**REPORT  
OF THE  
OSART  
(OPERATIONAL SAFETY REVIEW TEAM)  
MISSION  
TO THE  
FESSENHEIM  
NUCLEAR POWER PLANT  
FRANCE  
23 MARCH – 8 APRIL 2009  
AND  
FOLLOW-UP VISIT  
7-11 FEBRUARY 2011**

**DIVISION OF NUCLEAR INSTALLATION SAFETY  
OPERATIONAL SAFETY REVIEW MISSION  
IAEA-NSNI/OSART/011/152F**

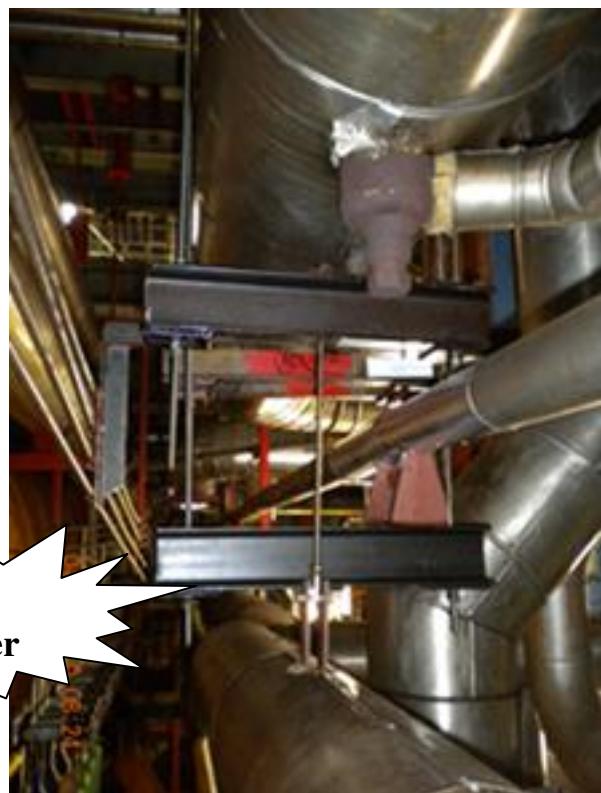
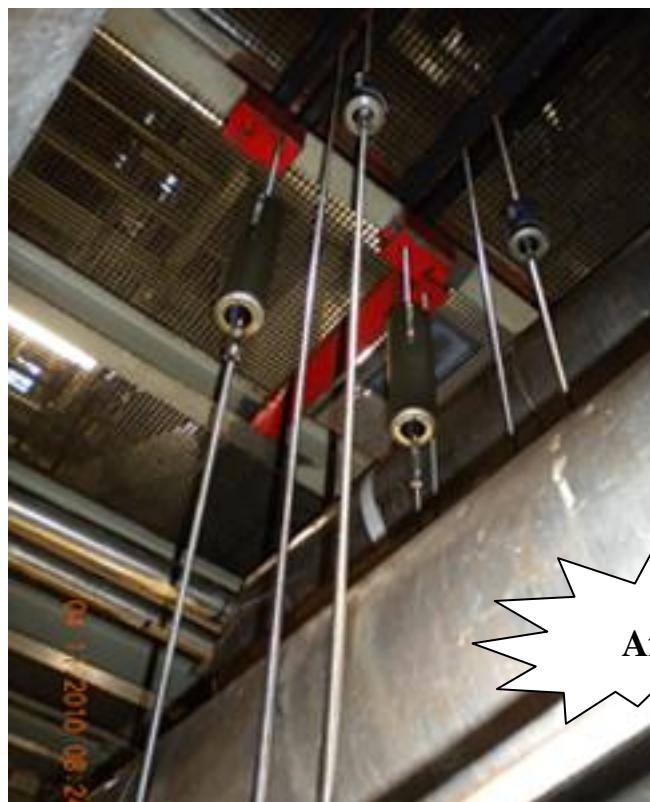
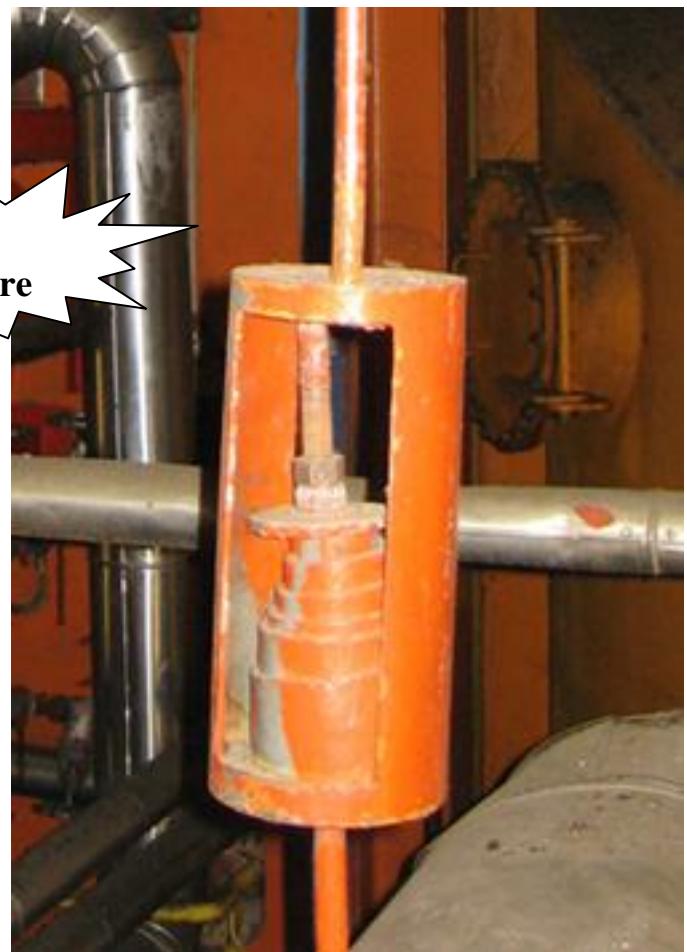
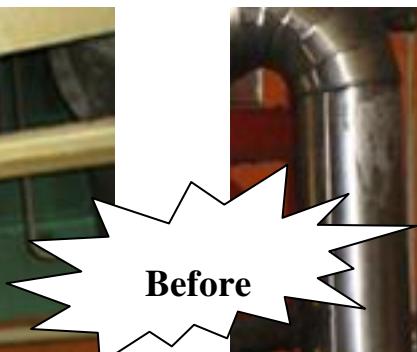
Tie-rod stubbed by being welded,  
No contact between shock pad and piping support,  
Several pipe supports on the same attachment point,  
No reference standards,  
Obsolete springs,

Calculate reference standards,  
Replace defective and obsolete parts,  
Return to a compliant condition as a whole.
